# Access Compliance Report

## Public Rights-of-Way (Curb Ramps)

Intersection ID: 44731	Main Street: BENFIELD_RD	Cross Street: PROSPERITY_PARK_DR	Location: E
ADA ID: 255686CF2F1F	Ramp Type: PerpDiag	Initial Pass/Fail: Fail	Overall Compliance: No
Severity Score: 37.5			
Codes/Mitigation Info/Possible Solution		Field Measurements/Component Compliance

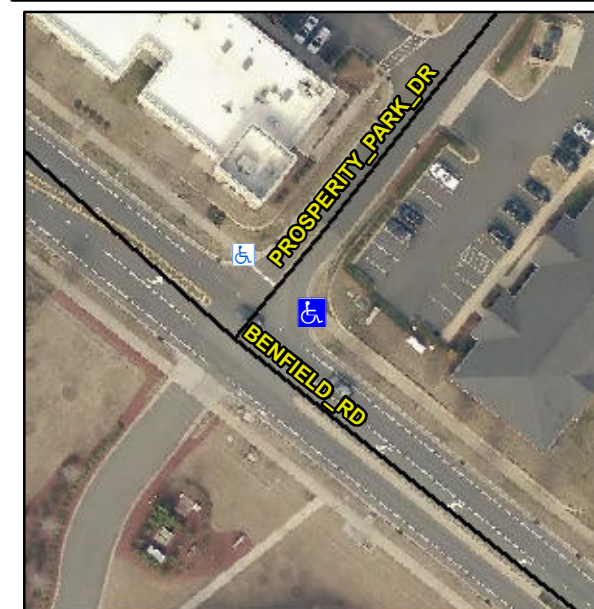
**R304.2.2, R304.5.3**

Compliance	Description	Data	Compliance	Description	Data
N/A	Ramp Length (in)	60.0	No	Ramp Slope (%)	20.0
Yes	Ramp Width (in)	49.0	No	Ramp XSlope (%)	5.1
N/A	Flare Type LT	N/A	N/A	Flare Type RT	N/A
N/A	Flare Slope LT (%)	N/A	N/A	Flare Slope RT (%)	N/A
N/A	Flare Traversable LT?	N/A	N/A	Flare Traversable RT?	N/A
N/A	Landing Length (in)	N/A	N/A	DWS Provided?	N/A
N/A	Landing Width (in)	N/A	N/A	DWS Contrast?	N/A
N/A	Landing Slope (%)	N/A	N/A	DWS Length (in)	N/A
N/A	Landing X Slope (%)	N/A	N/A	DWS Full Width?	N/A
N/A	Landing Curb? (Y/N)	N/A	N/A	DWS Offset (in)	N/A
N/A	Shared Landing?	N/A			
N/A	Gutter Ponding?	N/A	N/A	Gutter Slope (%)	N/A
N/A	Gutter Lip Ht (in)	N/A	N/A	Gutter X Slope (%)	N/A
N/A	Painted X Walk1?	No	N/A	Painted X Walk2?	No
	X Walk 1 Direction	To SW		X Walk 2 Direction	To NW
N/A	X Walk 1 Width (in)	N/A	N/A	X Walk 2 Width (in)	N/A
	X Walk 1 Slope (%)	2.5		X Walk 2 Slope (%)	3.0
	X Walk 1 X Slope (%)	1.0		X Walk 2 X Slope (%)	1.3

**Remove & Replace Curb Ramp With Two New Directional Ramps or Equivalent.**
